Access Compliance Report

Public Rights-of-Way

(Curb Ramps)

Intersection ID: 47670	Main Street: COLLINGHAM_DR	Cross Street: FENWAY_DR	Location: SW
ADA ID: CD98C11BB2F8	Ramp Type: BlendTrans1	Initial Pass/Fail: Fail	Overall Compliance: No
Severity Score: 8.75			
Codes/Mitigation Info/Possible Solution		Field Measurements/Component Compliance

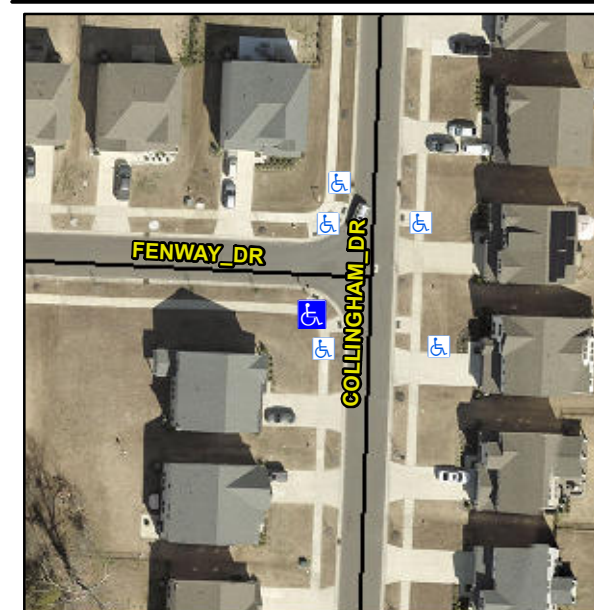
Not Found, R304.5.1

Compliance	Description	Data	Compliance	Description	Data
N/A	Ramp Length (in)	96.0	Yes	BlendTrans Slope (%)	4.7
No	Ramp Width (in)	41.0	Yes	BlendTrans XSlope (%)	1.2
N/A	Flare Type LT	N/A	N/A	Flare Type RT	N/A
N/A	Flare Slope LT (%)	N/A	N/A	Flare Slope RT (%)	N/A
N/A	Flare Traversable LT?	N/A	N/A	Flare Traversable RT?	N/A
N/A	Landing Length (in)	N/A	N/A	DWS Provided?	N/A
N/A	Landing Width (in)	N/A	N/A	DWS Contrast?	N/A
N/A	Landing Slope (%)	N/A	N/A	DWS Length (in)	N/A
N/A	Landing X Slope (%)	N/A	N/A	DWS Full Width?	N/A
N/A	Landing Curb? (Y/N)	N/A	N/A	DWS Offset (in)	N/A
N/A	Shared Landing?	N/A			
N/A	Gutter Ponding?	N/A	N/A	Gutter Slope (%)	N/A
N/A	Gutter Lip Ht (in)	1.0	N/A	Gutter X Slope (%)	N/A
N/A	Painted X Walk1?	No	N/A	Painted X Walk2?	N/A
	X Walk 1 Direction	To N		X Walk 2 Direction	N/A
	X Walk 1 Width (in)	N/A		X Walk 2 Width (in)	N/A
	X Walk 1 Slope (%)	1.1		X Walk 2 Slope (%)	N/A
	X Walk 1 X Slope (%)	3.1		X Walk 2 X Slope (%)	N/A

N/A	Ramp inside XWalk1?	N/A	N/A	Ramp inside XWalk2?	N/A
	Road Slope (%)	3.1		Clear Space?	N/A
	Road X Slope (%)	1.1	N/A	Clear Space to XWalk (in)	N/A
N/A	Any Obstructions?	N/A	N/A	Storm Grate/Utility Hazard?	N/A
	Obstruction Type			Storm Grate/Utility Type	
		N/A			N/A
			Yes	Surface Condition? (G/P)	Good
			No	Curb Slope (%)	6.9

Remove & Replace Curb Ramp With Two New Directional Ramps or Equivalent.
